Item Name: Crosstube Turning Detail

DART AEROSPACE LTD		Work Order:	95462
Description: Crosstube Assembly (412 High Aft)		Part Number:	D412-664-243
Inspection Dwg: D412-664-243 Rev: E		Page 1 of 2

DRAWING NO. D412-664-243	TITLE CROSSTUBE ASSEMBLY (412 HI AFT)	REV. E	DART AEROSPACE LTD ENGINEERING ORDER		D.E.O. NO. D412-664-243-E-1	SHEET NO. SHEET 1 OF 2	SCALE NTS
DRAWN	CHECKED	MFG. APPR.	APPROVED	DE APPR.			
DATE 11.03.31	DATE 11/03/31	DATE 11.03.31	DATE 11/03/31	DATE 11.03.31

DRAWING NO. D412-664-243	TITLE CROSSTUBE ASSEMBLY (412 HI AFT)	REV. E	DART AEROSPACE LTD ENGINEERING ORDER		D.E.O. NO. D412-664-243-E-4	SHEET NO. SHEET 1 OF 3	SCALE NTS
DRAWN 92	CHECKED A	MFG. APPR. A	APPROVED MP		DE APPR. MP		
DATE 12.08.21	DATE 12.08.30	DATE 12.08.30	DATE 12/8/30		DATE 12.08.30

**D412-664-243
ASSEMBLY DETAIL**

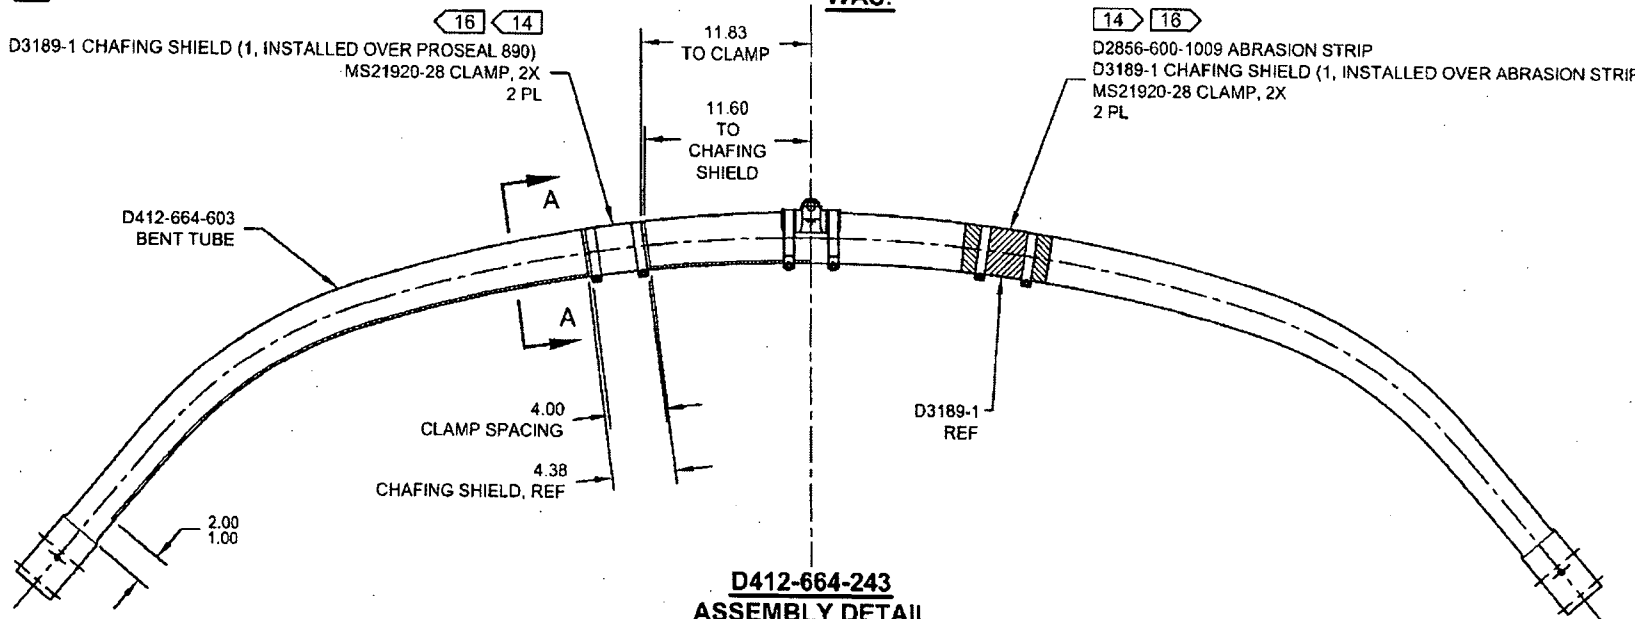
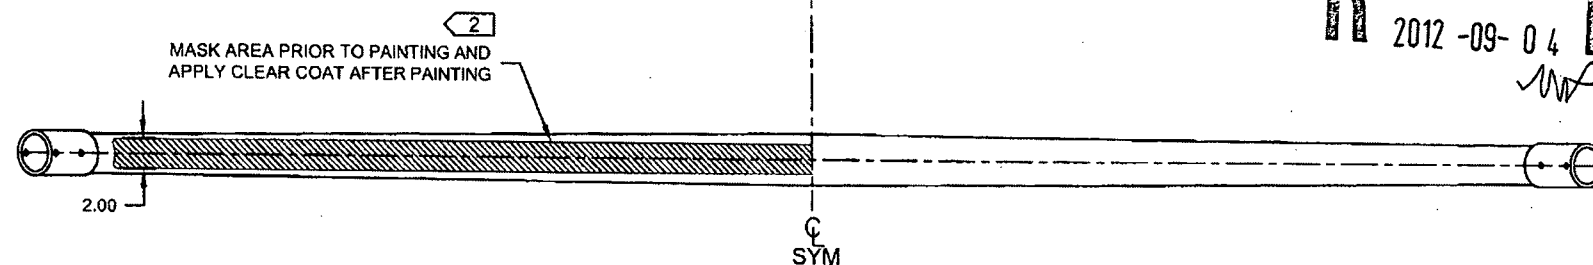
REMOVED ABRASION STRIP IN FAVOR OF A THIN LAYER OF PROSEAL 890. UPDATE INSTALLATION OF CHAFING SHIELDS AND REDUCE TORQUE TO 40-50 IN-LBS. THIS ENGINEERING ORDER SUPERCEDES DEO D412-664-243-E-1.

D3189-1 CHAFING SHIELD (1, INSTALLED OVER PROSEAL 890)
MS21920-28 CLAMP, 2X
2 PL

D2866-600-1009 ABRASION STRIP
D3189-1 CHAFING SHIELD (1, INSTALLED OVER ABRASION STRIP)
MS21920-28 CLAMP, 2X
2 PL
